THE VILLAGE

MASTER PLAN AMENDMENT

LUSTER
 THE VILLAGE
 REVISED MASTER PLAN

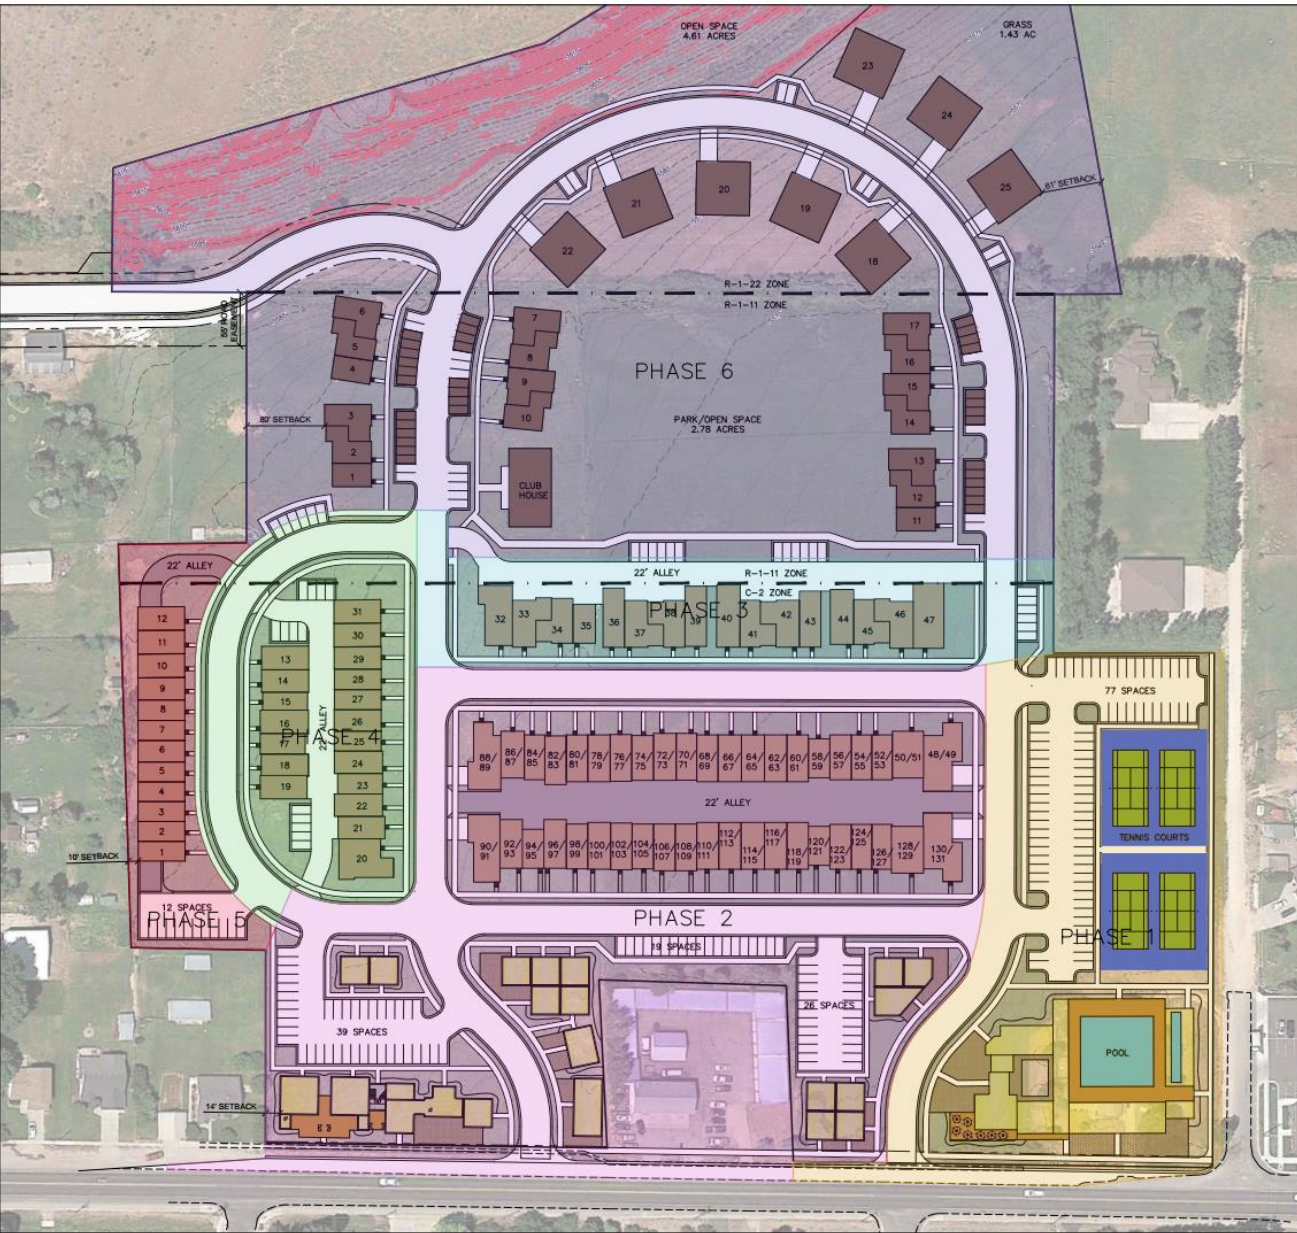
REVISION NOTE — 21 OCT 2021:
 REVISED TO ADD RESIDENTIAL PARKING FOR 3 BEDROOM UNITS. ALSO SEE PARKING TABLE

REVISION NOTE — 29 OCT 2021:
 COMMERCIAL BUILDINGS PAID, GROSS AND NET USEABLE SQUARE FOOTAGES HAVE BEEN UPDATED BY ARCHITECT.
